Report on Consultation (Route Options) Glendye Wind Farm Grid Connection June 2024

REF: LT468/469

Glendye Wind Farm Grid Connection - Report on Consultation (Route Options)

Figure 1: Proposed Route

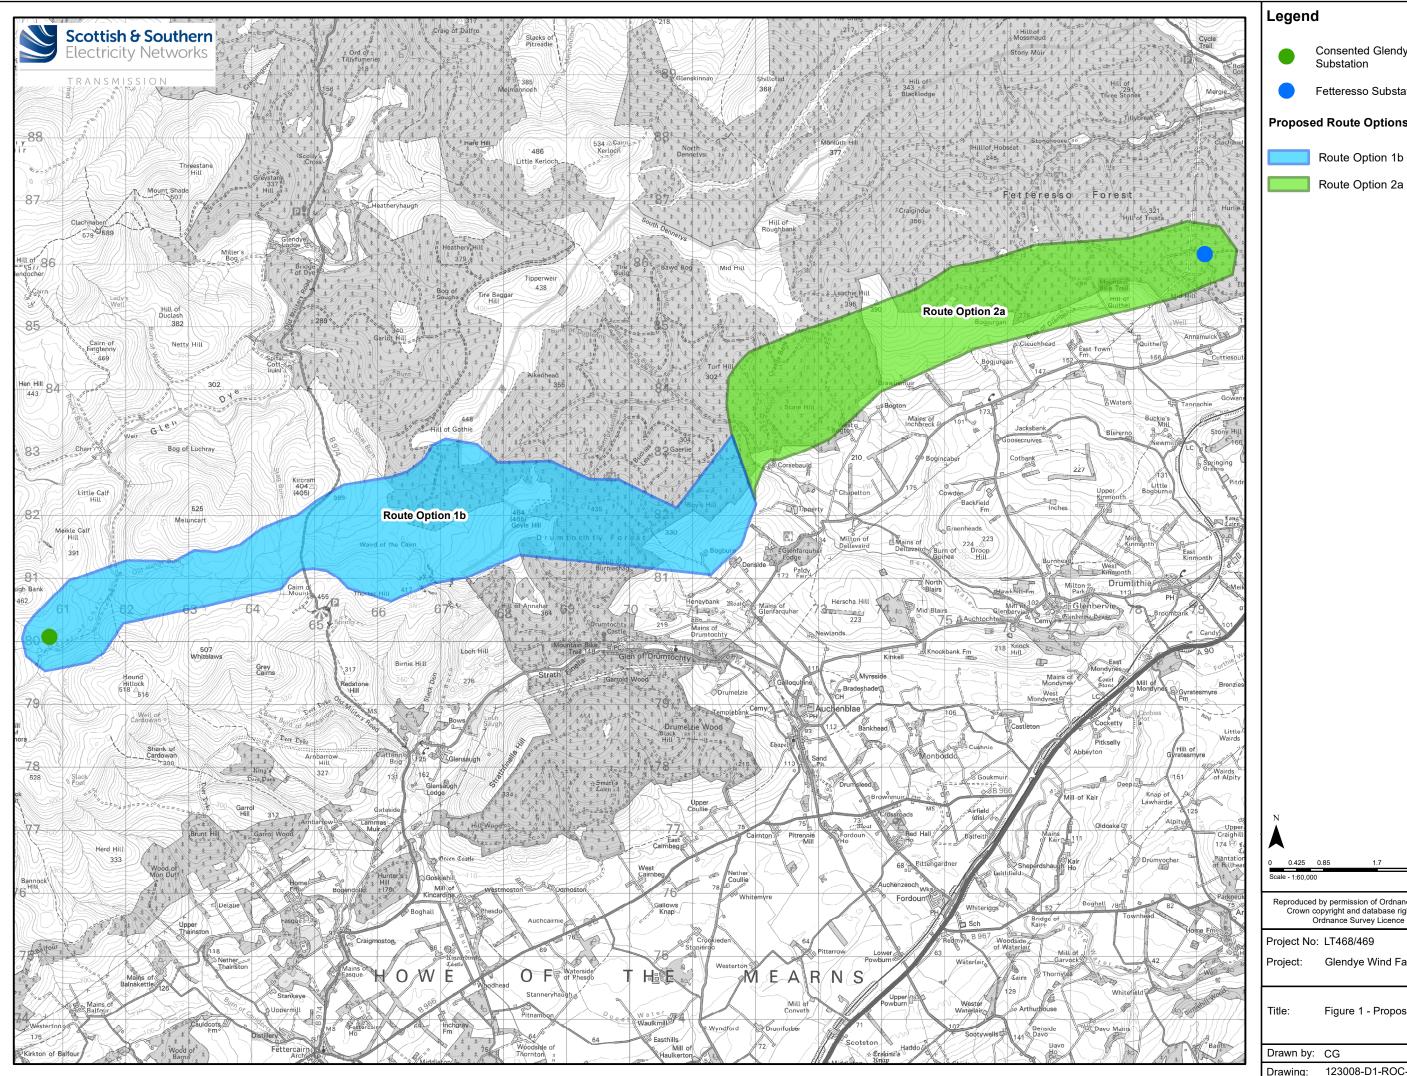
- 7.1.2 For western route options, the Consultation Document (February 2024)¹ identified the River Dee SAC, presence of Class 1 and 2 peatland, landscape and visual effects and the Cairn o' Mount cairns Scheduled Monument as key environmental constraints. From an engineering perspective, access opportunities and steep terrain (particularly in the case of Route Option 1c) were noted as important considerations. Stakeholder comments also noted these constraints, and there were a number of concerns raised by the local community in relation to the landscape and visual impact of this route option. As such, Route Option 1c is not taken forward.

- 7.1.3 In determining whether Route Option 1a or 1b should form part of the proposed route, SSEN Transmission have concluded that given the proximity of Route Option 1a to the River Dee SAC, the presence of a regionally significant cultural heritage site within this route, the proposals for woodland creation and peatland restoration as part of the Glen Dye Moor Restoration Project, as well potential for landscape and visual effect, that Route Option 1b is to be taken forward as part of the proposed route. It is recognised however that this route does cross areas of Class 1 and 2 peatland some of which is subject to restoration proposals, and the potential setting effects on Cairn O'Mount Cairns Scheduled Monument and wider landscape and visual effects will require careful consideration in order to find a suitable alignment within this route option.

- 7.1.4 For eastern route options, the Consultation Document (February 2024)¹ noted the presence of forestry (particularly for Route Option 2a) and the more settled and agricultural landscape of Route Option 2b, as well as its proximity to properties, as key constraints. There were a number of responses received from the local community in relation to Route Option 2b, citing concerns in relation to proximity to houses and people, private water supplies, potential impact on agriculture and cumulative effect with other electrical infrastructure (existing and proposed). There was a strong preference for Route Option 2a over Route Option 2b from community responses, given the greater distance of Route Option 2a from properties and other existing and proposed electrical infrastructure projects, as well as the potential screening effect of forestry.

- 7.1.5 Having considered this feedback, SSEN Transmission has concluded that the proposed route option to be taken forward to the alignment selection stage should comprise Route Option 1b and Route Option 2a. The proposed route can be seen in **Figure 1**.
